Appln. No.: 10/540,933
Shchukin et al.
Reply to Office Action of October 10, 2006

Amendments to the Drawings

FIG. 1

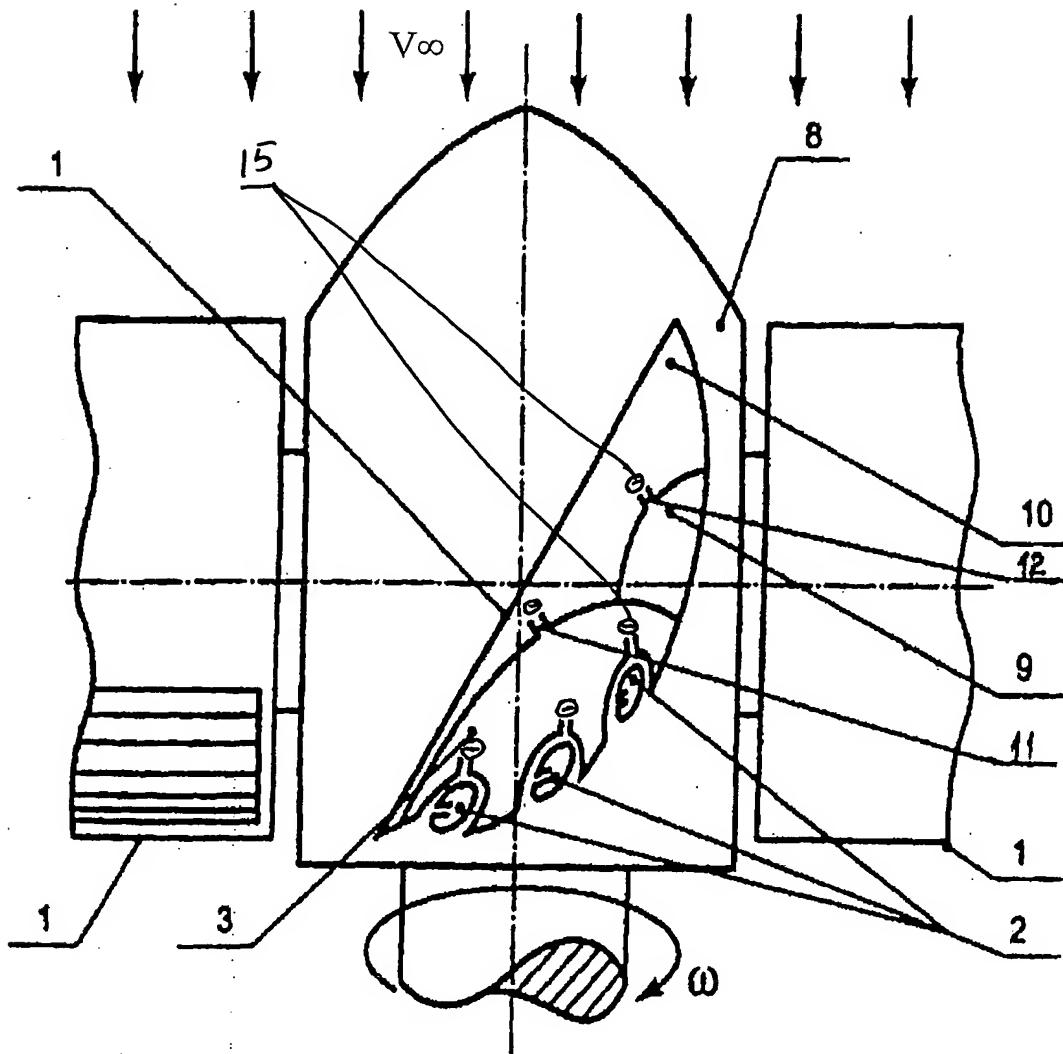
In Figs. 1 and 2, elements 15 that control air consumption now are illustrated. The elements are described in the specification at page 2, lines 11-2, page 4, line 30, and in original claim 5. Therefore, Applicants respectfully submit that this amendment adds no new matter to the application and earnestly solicit entry thereof.

The drawings were objected to because the view numbers are not larger than the reference characters (37 C.F.R. § 1.84(u)(2)) and because not every feature recited in the claims was identified on the drawings (37 C.F.R. § 1.83(a)). “[E]lements for controlling the consumption of air” of claim 5 and the “turbine” of claims 6 and 11 were not shown on the drawings.

FIG. 3

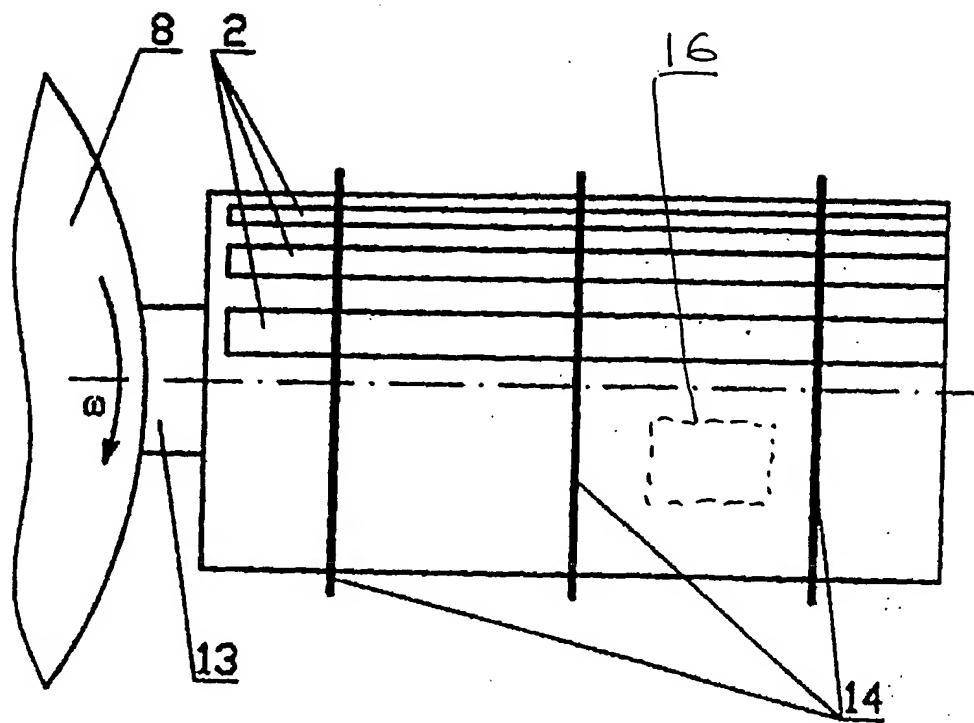
In Fig. 3, the turbine that draws air from receiver 10 is illustrated as present in the blade. The turbine is described in the specification at page 2, lines 27-28, page 4, lines 32-33, and original claim 6. Therefore, Applicants respectfully submit that this amendment adds no new matter to the application and earnestly solicit entry thereof.
